**101 Bayham Street
London NW1 0AG**

**Acoustic Design Review
Report 27909.ADR.01.RevA**

QOB Interiors

Report 27909.ADR.01			
Revision History			
First Issue Date: 17/04/2024			
A	22/04/24 Rooftop plant assessment revised – two ASHPs removed, reduced duty during night time considered.	D	
B		E	
C		F	
Written by:		Checked by:	Approved by:
Steven Leslie MIOA Consultancy Manager		Daniel Stuart MIOA Senior Consultant	Oliver Packman MIOA Principal Consultant
Disclaimer KP Acoustics Ltd. has used reasonable skill and care to complete this technical document, within the terms of its brief and contract with the resources devoted to it by agreement with the client. We disclaim any responsibility to the client and others in respect of any matters outside the stated scope. This report is confidential to the client and we accept no responsibility to third parties to whom this report, or any part thereof, is made known. KP Acoustics Ltd. accepts no responsibility for data provided by other bodies and no legal liability arising from the use by other persons of data or opinions contained in this report. KP Acoustics Ltd. 2024

Figure 5.2 Proposed roof plant layout

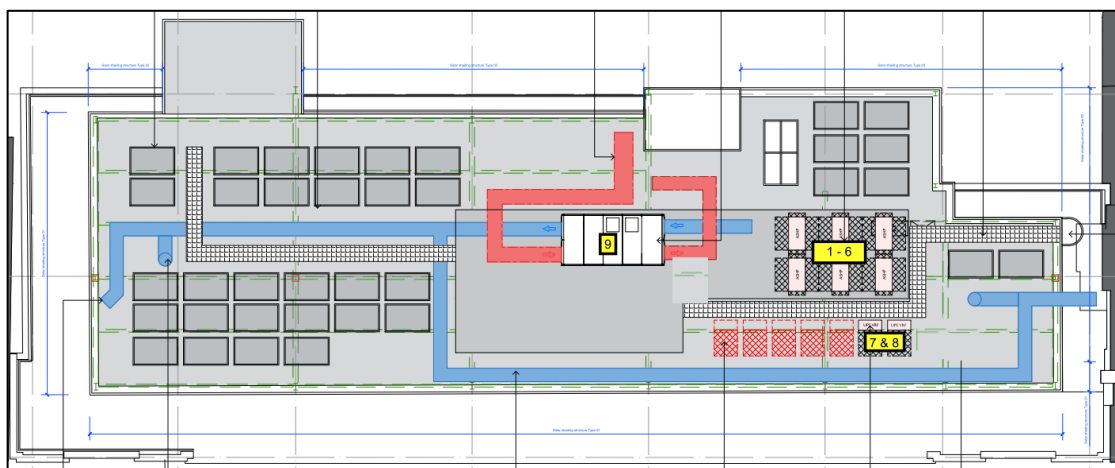
It is understood that during nighttime hours, the Basement Condenser (item 1) will be off and the remaining condensers (items 2 – 6) will be running in Low Noise Mode 4. The AHU and VRFs will continue to operate at full duty.

Based on the plant layout and the noise data provided, we have calculated the noise emissions to the noise sensitive receptors. Noise mitigation measures will be required in order to meet the required noise criteria.

The ASHP enclosure should provide the above minimum levels of attenuation to all sides of the plant and over the top. We would expect that the above specification could be achieved with an enclosure formed from 100 - 1500mm deep louvres or a bespoke enclosure design.

Title
Proposed
Basement Plan

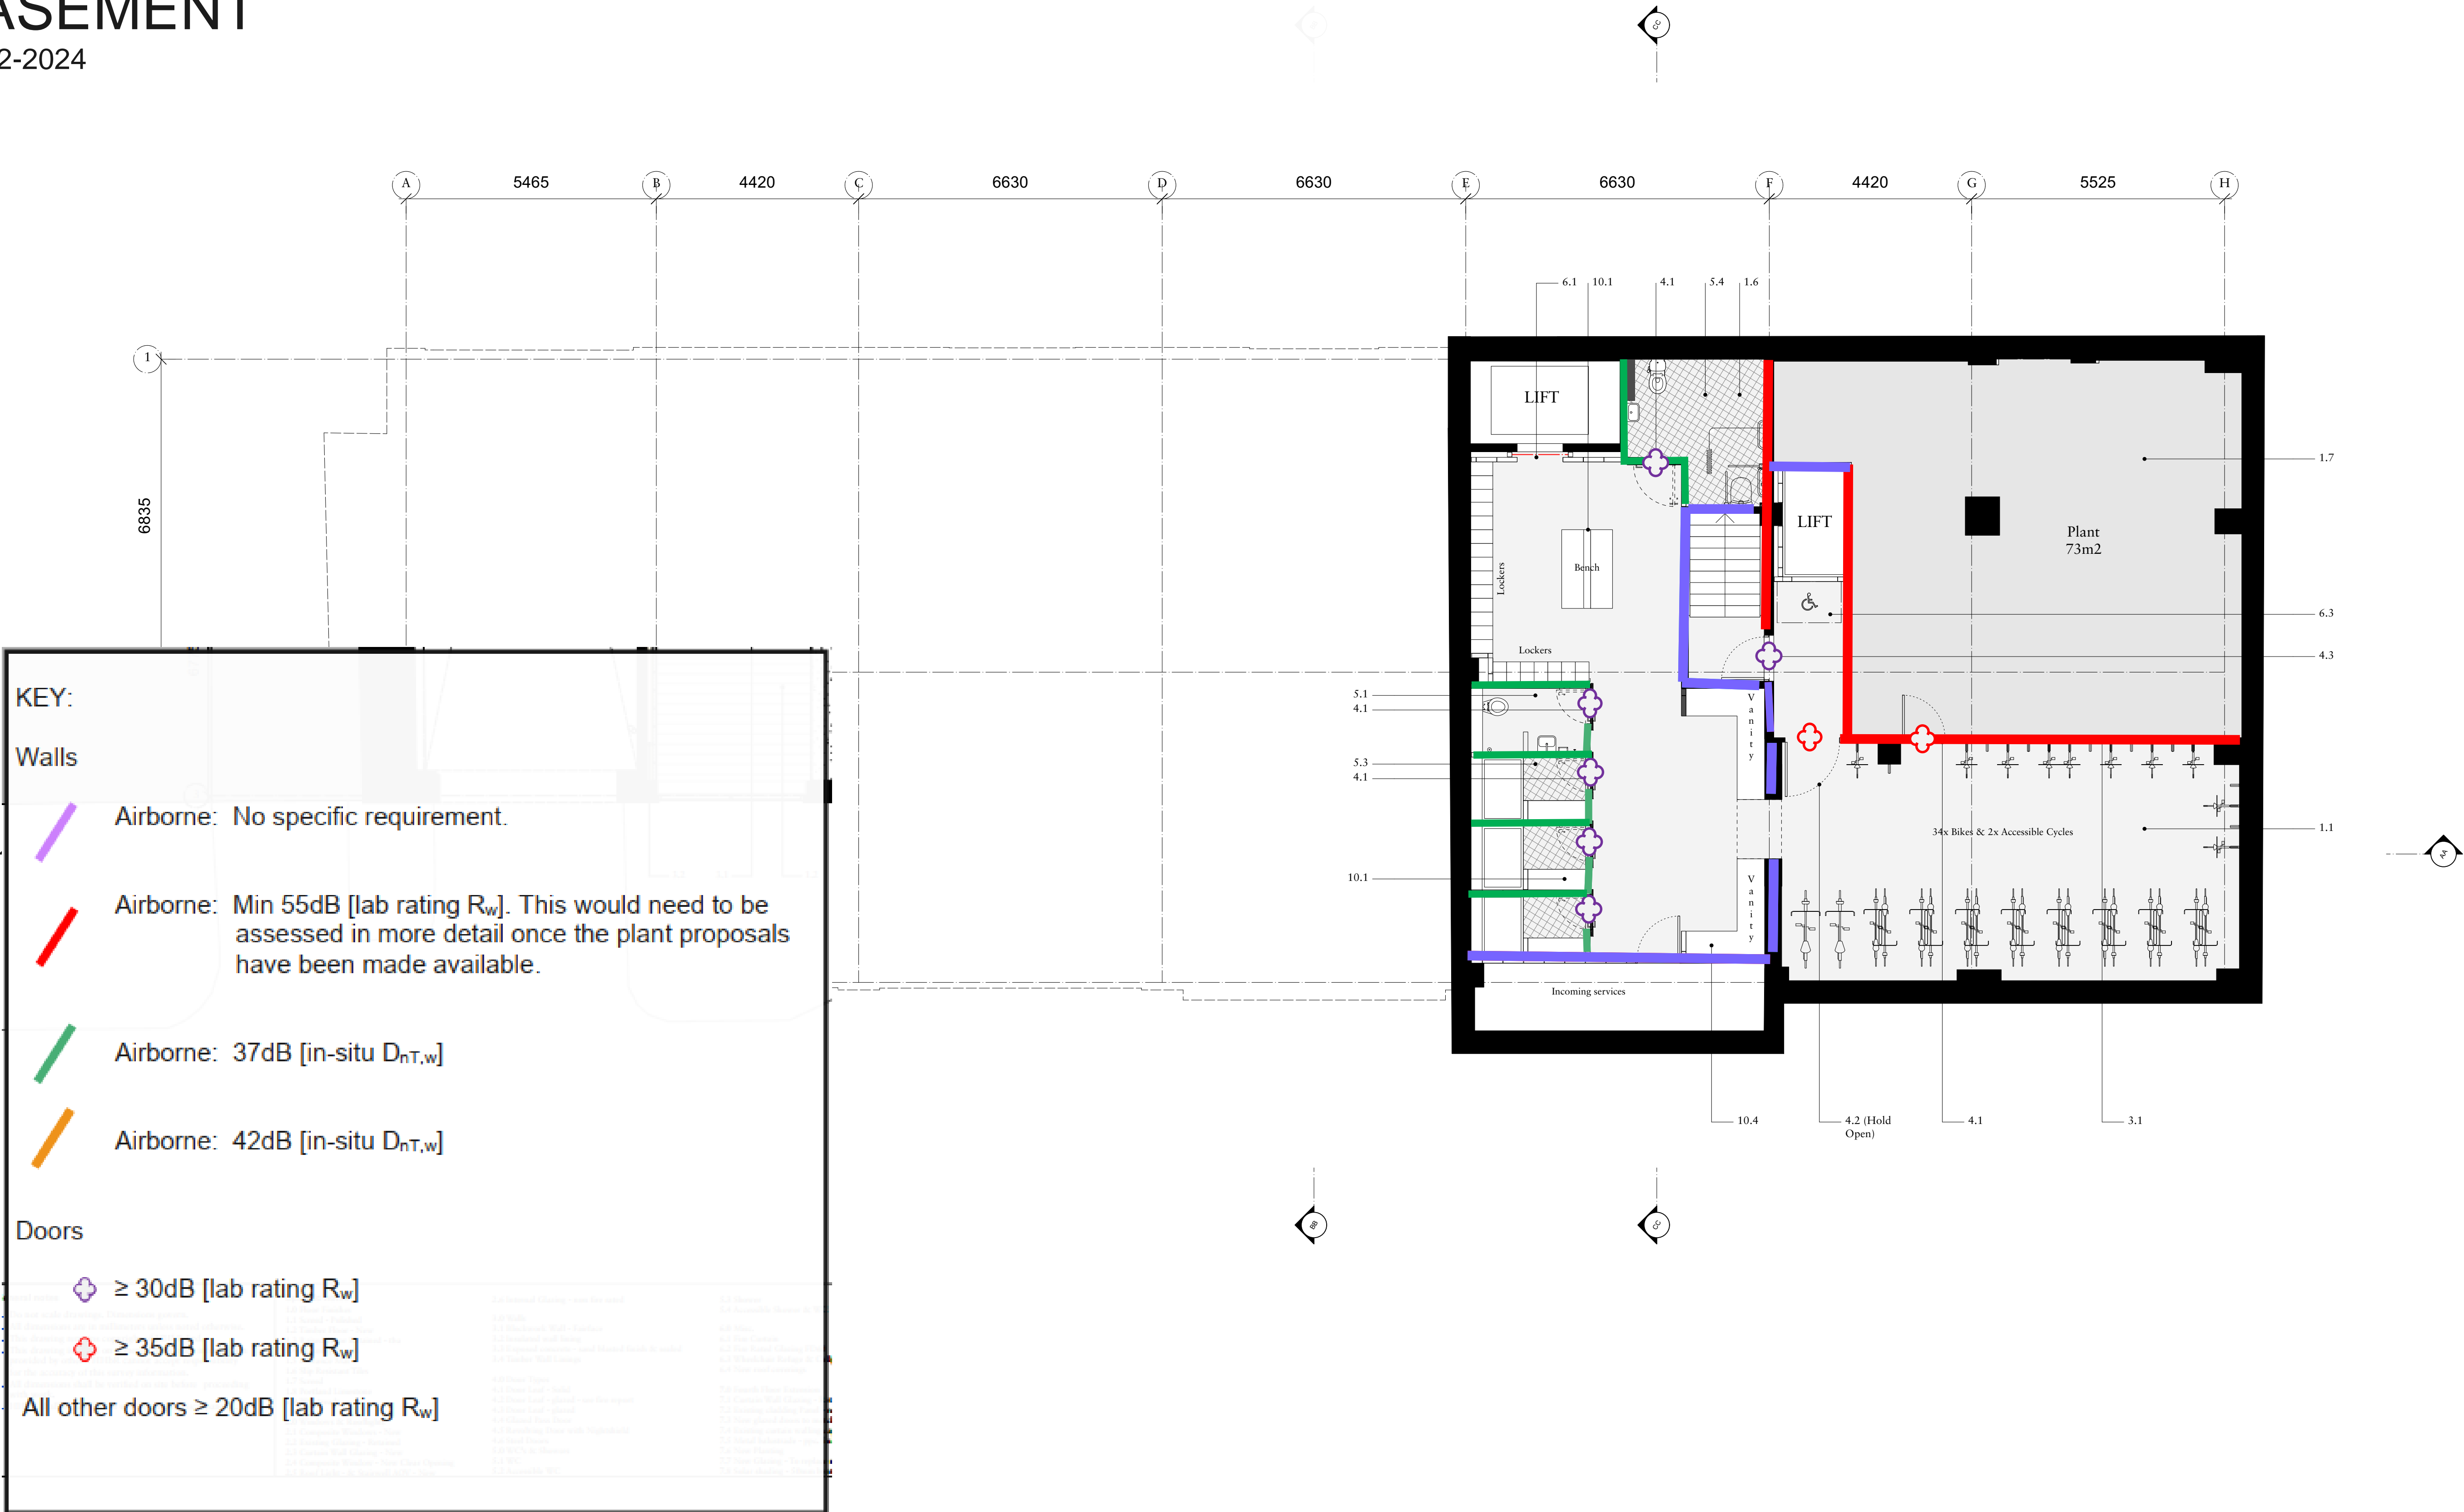
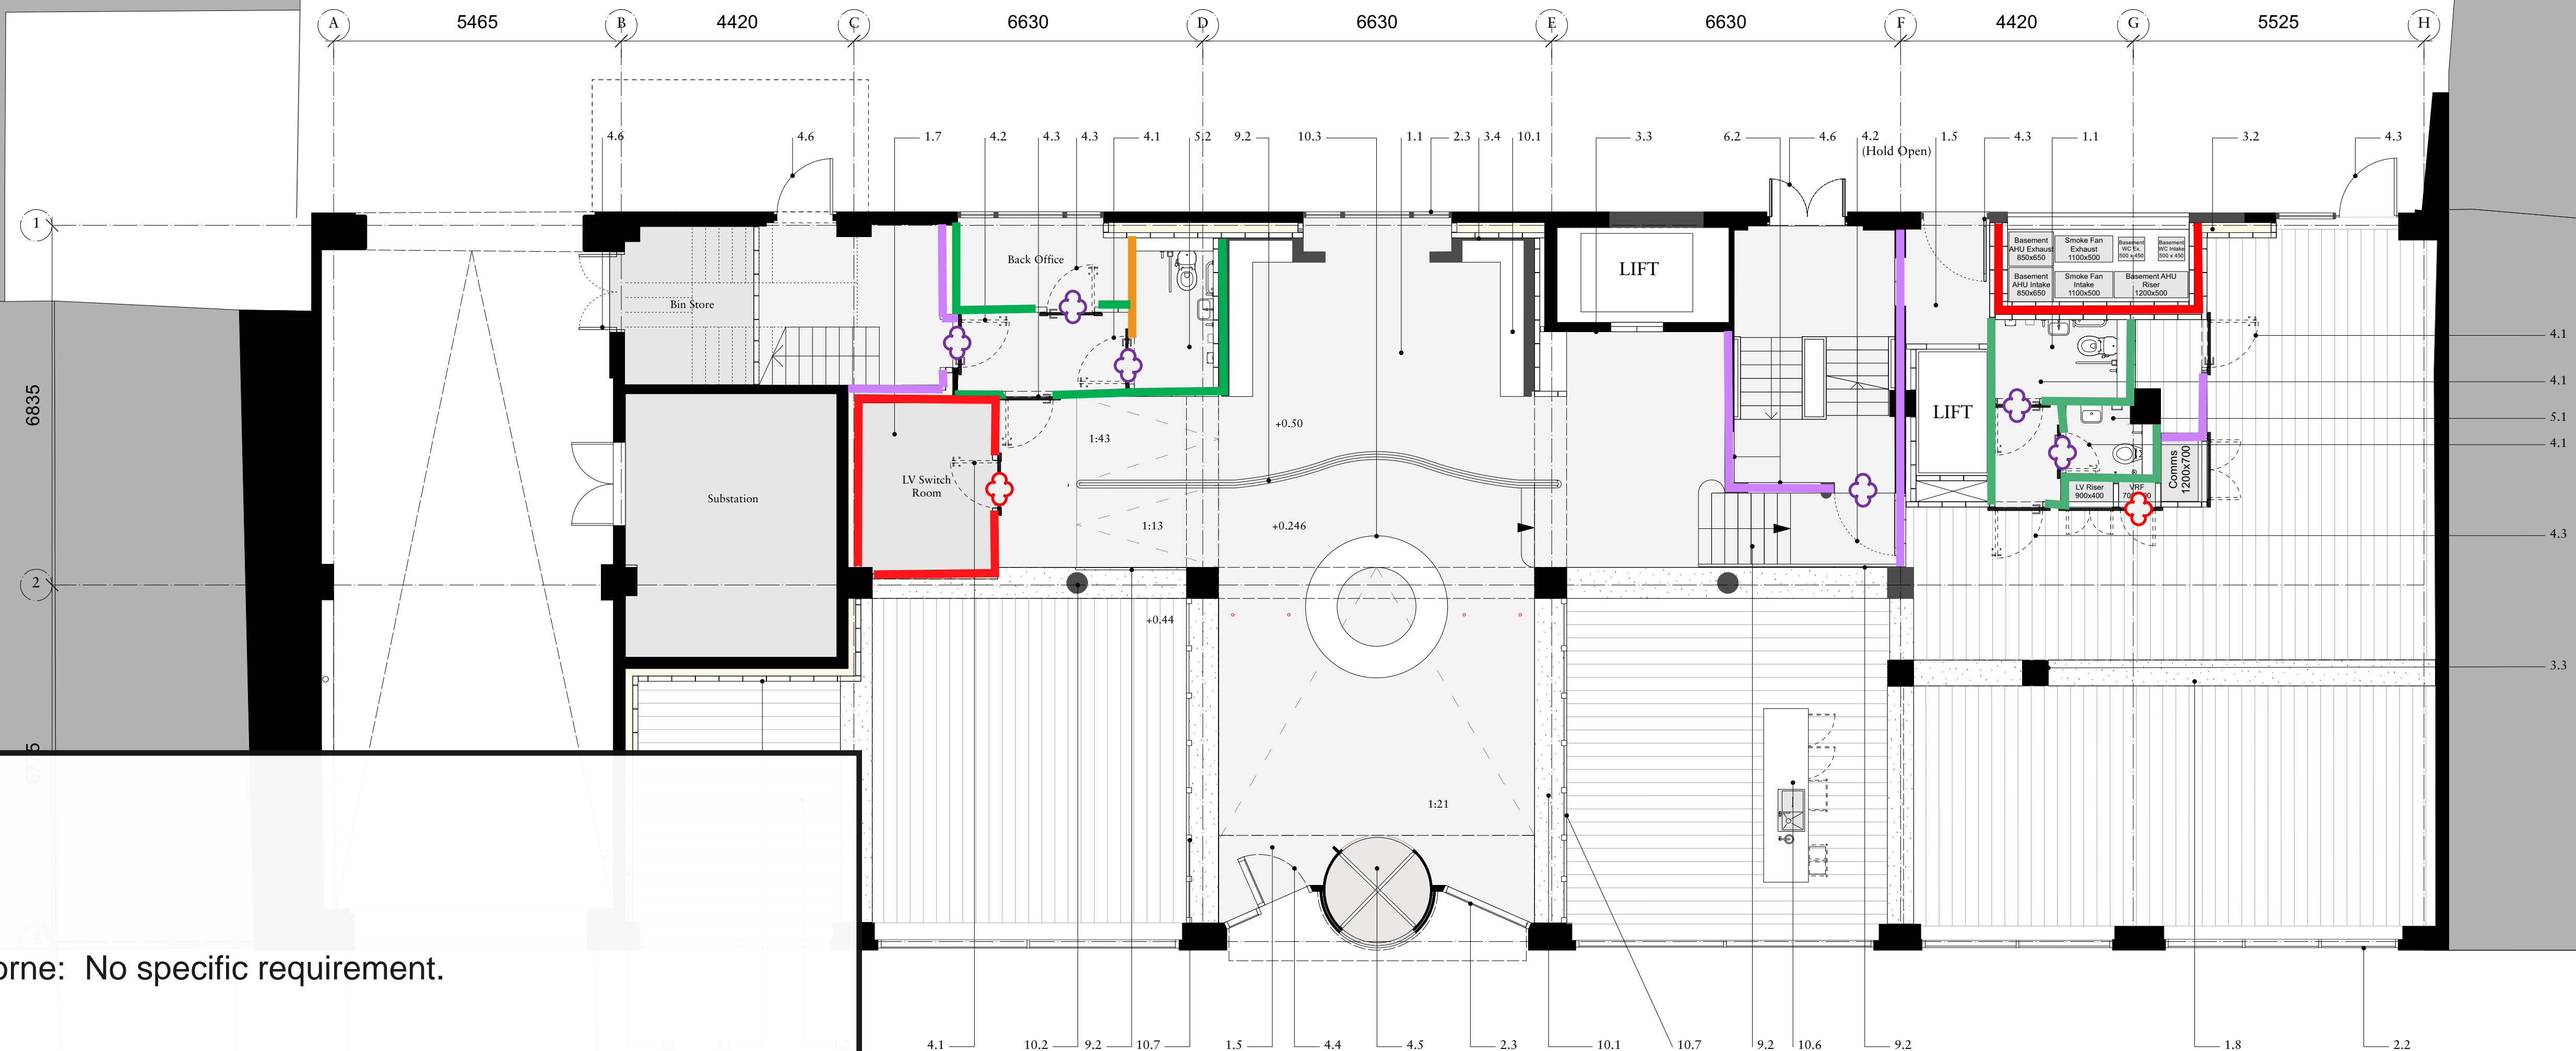
Airborne: Min 55dB [lab rating R_w]. This would need to be assessed in more detail once the plant proposals have been made available.
